**WARRANTY
BULLETIN**

WB15-53A

DATE :	NOVEMBER 2015	SECTION :	04 - Exhaust
EXPIRATION:	NOVEMBER 2017		
SUBJECT :	DIESEL PARTICULATE FILTER (DPF) – LOOSE PLUGS

FIRST PLUG

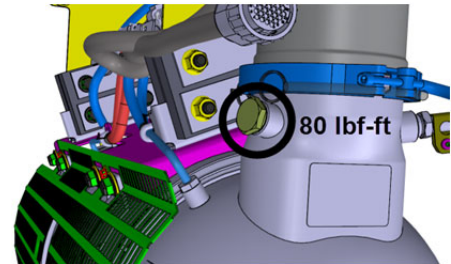
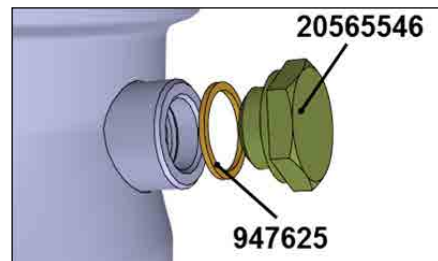
1. Check if the M20 hexagonal plug located to the right side of the DPF (see image at right) is properly tightened.

Note: To gain access to the plug, detach the Velcro strip on the insulating sleeve.

2. Apply a torque of **80 lbf - ft**.

If the plug is missing, order plug #20565546 and copper seal #947625.

Note: You can apply torque seal inspection lacquer or similar product to certify that tightening has been checked.

3. Attach the Velcro strip on the insulating sleeve once done.

SECOND PLUG

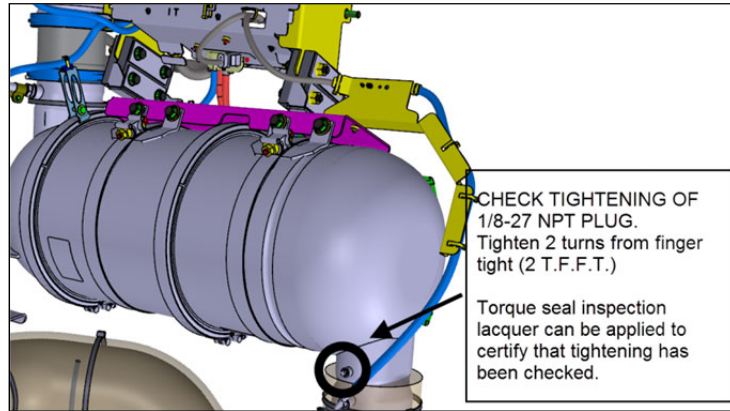
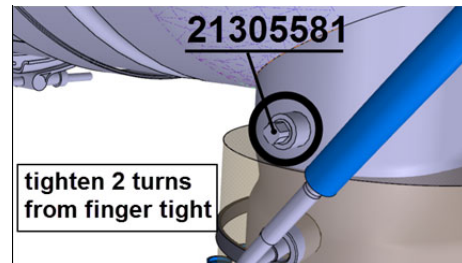
1. Check if the 1/8-27 NPT plug located to the left side of the DPF (at the inlet of DPF) is properly tightened.

Note: To gain access to the plug, detach the Velcro strip on the insulating sleeve.

2. Tighten 2 turns from finger tight (2 T.F.F.T.).

If the plug is missing, order plug #21305581.

Note: You can apply torque seal inspection lacquer or similar product to certify that tightening has been checked.

Note: Copper anti-seize compound can be applied on this particular plug if necessary.

3. Attach the Velcro strip on the insulating sleeve once done.
